SUBJECT: ISSUANCE OF AMENDMENT NO. 169 TO FACILITY OPERATING LICENSE  
NO. NPF-6 - ARKANSAS NUCLEAR ONE, UNIT NO. 2 (TAC NO. M92064)

AMENDMENT TO FACILITY OPERATING LICENSE

ATTACHMENT TO LICENSE AMENDMENT NO. 169

SAFETY EVALUATION BY THE OFFICE OF NUCLEAR REACTOR REGULATION

Figure  
 4.2-19

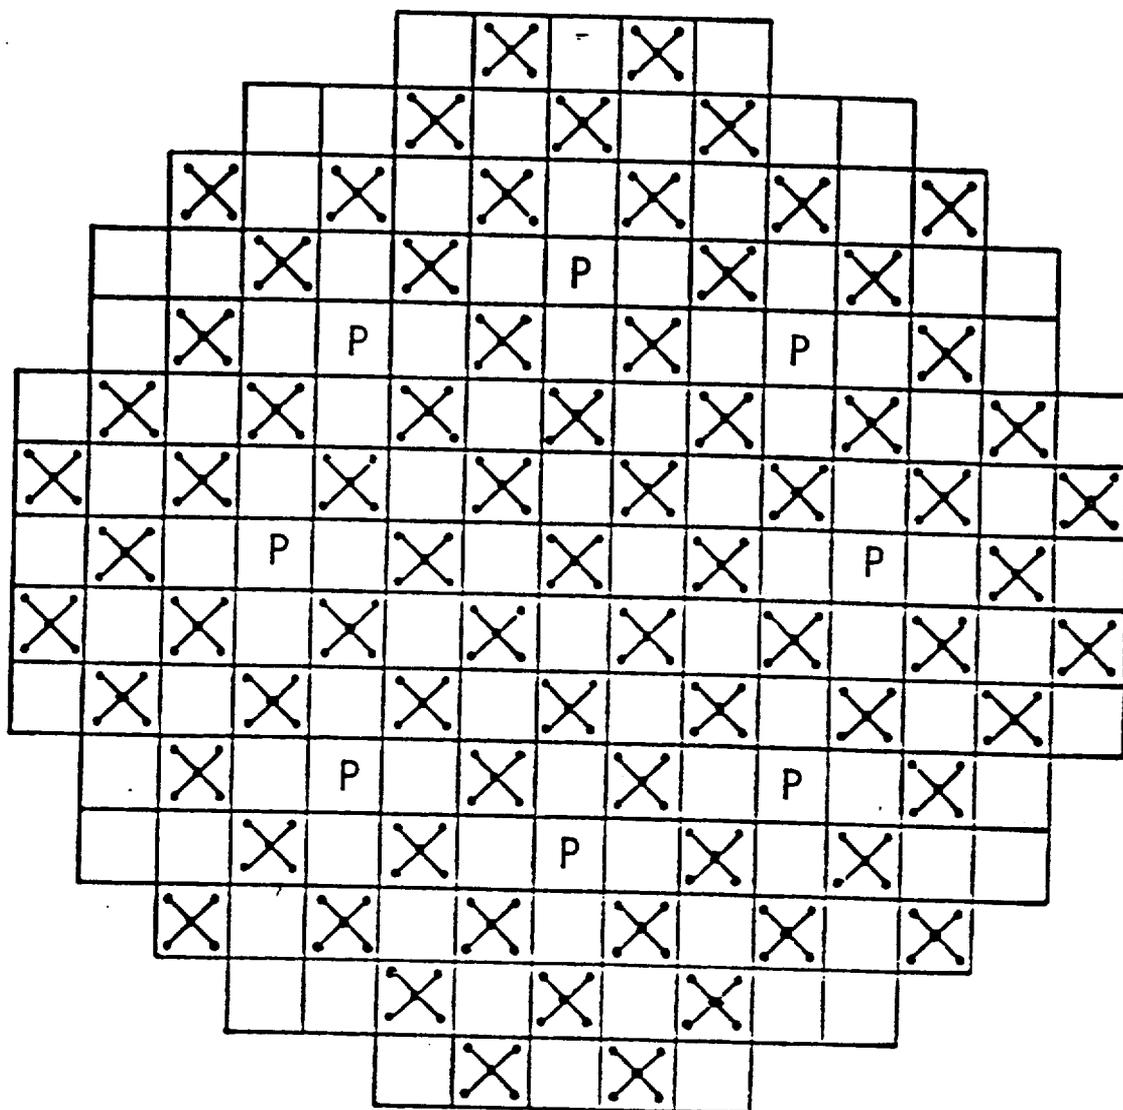
The amendment deletes TS requirements associated with part length control assemblies.

In addition to the 73 full length CEAs, the ANO-2 reactor currently contains eight PLCEAs. The PLCEAs contain full strength neutron absorber sections in only the upper 10% of their length and are intended to provide control of axial power distribution. By the end of the current fuel cycle, Cycle 11, the CEAs will have operated to the end of their evaluated design life and will be replaced during the refueling outage. During this outage, the licensee will also replace the eight PLCEAs with full length CEAs and will designate this as Group P CEAs.

The licensee's operating experience has shown that the CEAs alone are capable of controlling axial power during plant operation and, therefore, PLCEAs are not necessary. In addition, replacement of the PLCEAs with full length CEAs will allow the Group P CEAs to be used as an additional control group and will provide additional shutdown reactivity worth. The addition of the full length rods is an enhancement to safety in that additional rods will be available to shut down the reactor. New power dependent insertion limits (PDILs) will be developed to allow this application and will be located in the ANO-2 Core Operating Limits Report (COLR). Based on these facts, the proposed TS changes which eliminate reference to PLCEAs are acceptable.
